December 18th 2013

On December 11, 2013 the Ocean Beach Planning Board held a Special Meeting and voted 8-0-0 to approve with modification the Draft Community Plan Update. The recommended modification(s) are:

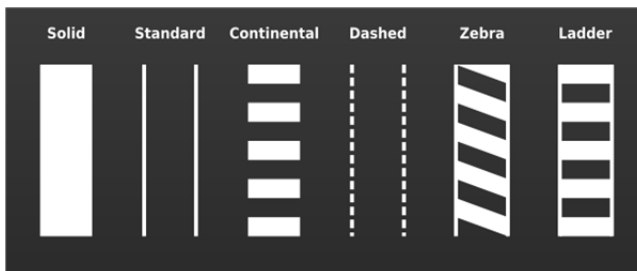
- Modify the 2nd paragraph of the introduction of the **Mobility Element (Page ME 3)** to read: *“... enhancing desirable outcomes associated with the City of Villages growth strategy in terms of bikeability, walkability and pedestrian orientation.”*
- Modify **Recommendation 3.1.1** as follows: *“...including, but not limited to, sidewalks and curb ramps where missing, bulbouts, ~~and enhanced marked crosswalks~~ traffic signals timed for pedestrians, alternative crosswalk striping patterns and raised crosswalks aimed at improving...”*
- Add the following image to **Section 3.1**:

OB Planning Board District 1 Representative John Ambert has emailed this image to City staff.
